100-ohm Differential trace comment

75-ohm-Single-ended trace comment

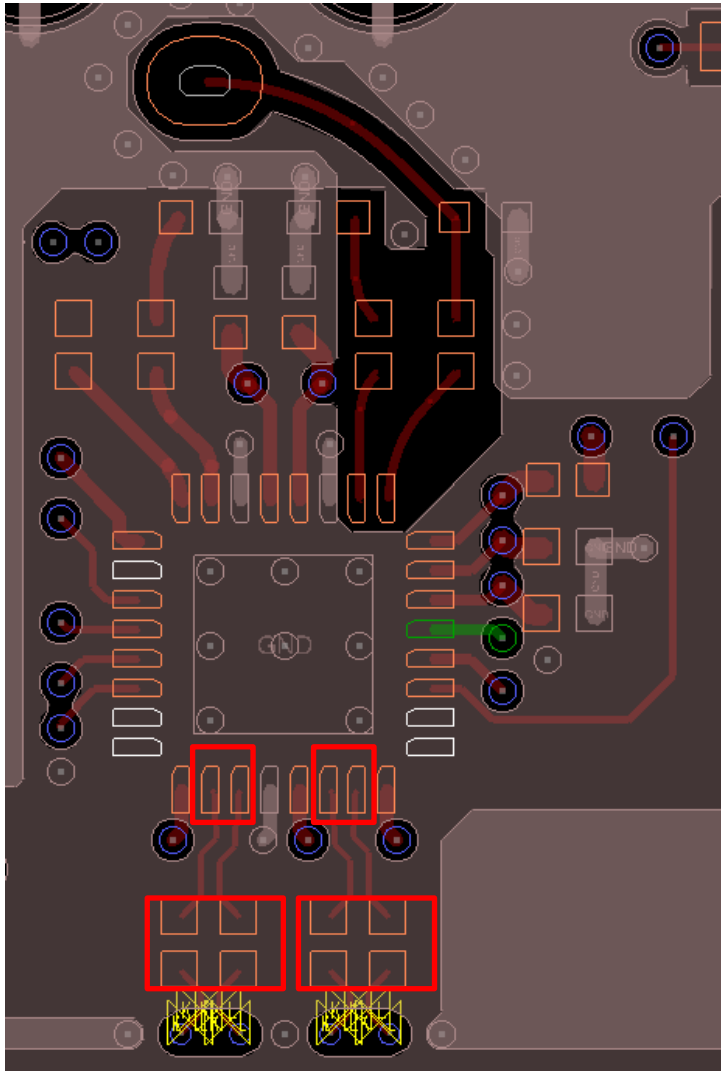
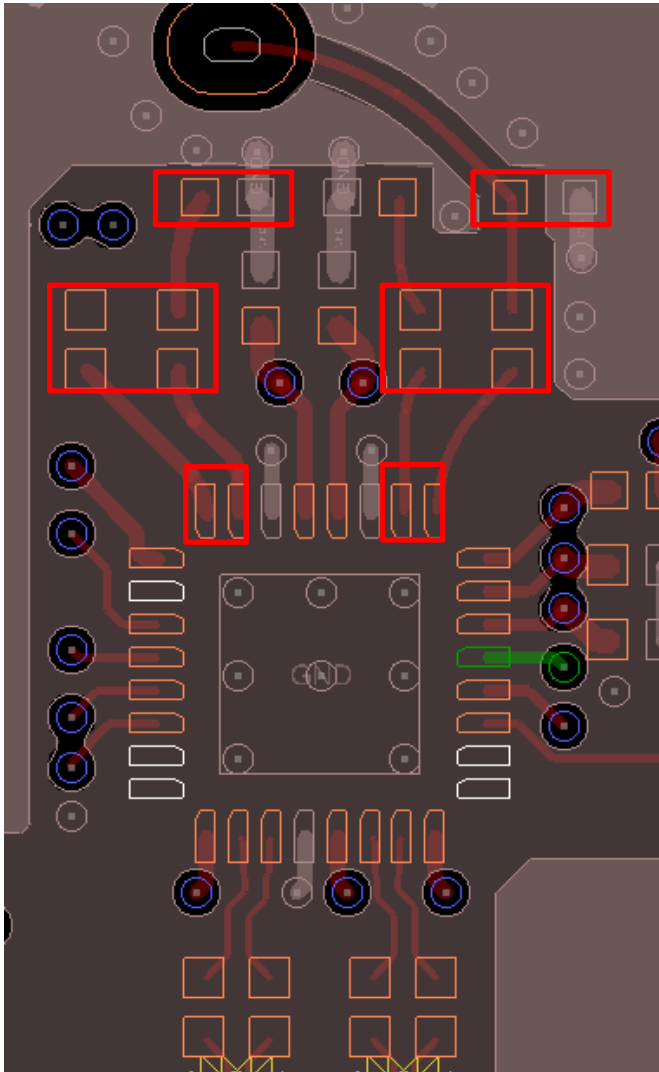
- Provide void – no GND or VCC plane – under AC coupling Caps and 100-ohm IN0 and OUT0
- SDI_OUT is not used – trace referenced to layer GND02

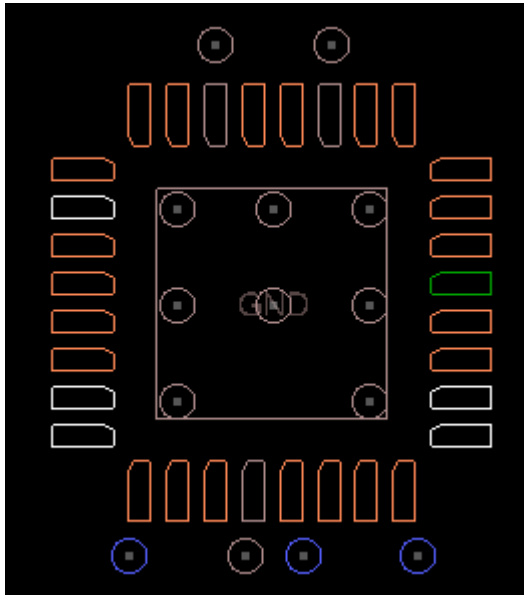
- Provide void – no GND or VCC plane – under AC coupling Caps, high speed trace, and protection device
- Please discuss with 12G SDI BNC connector to make sure BNC layout is optimized for 12G SDI operation
